PRFUP20251237

PSI	PUGET SOUND ENERGY	ENGR1 LUMEN TK#5044288	INCIDENT N/A	MAOP N/A
DESIGNED BY POTELOCO		RPLC (10) POLES, EXT. SEC RISER, ZIPTIE SEC, WRKOUT SEC.	Gas Order N/A	Elect Order 186061933
		711 W MAIN PUYALLUP, WA 98371	SCALE AS NOTED	PAGE 1/1

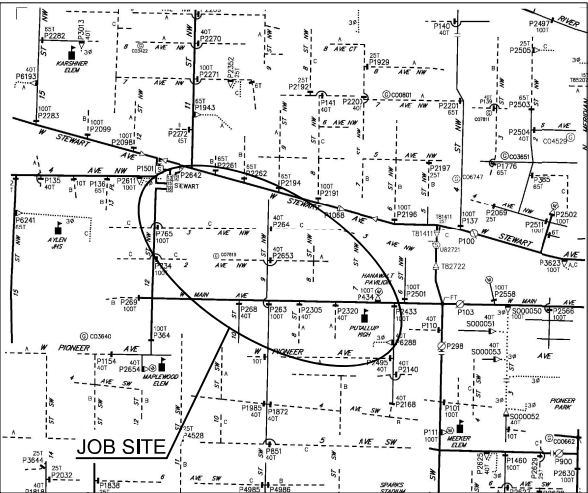
Site specific notes, pole tables, and other content on the site plan does not match the permit application for removing six poles. Redact any unrelated work from the site plan or update the project description on the application to match the proposed scope of work.
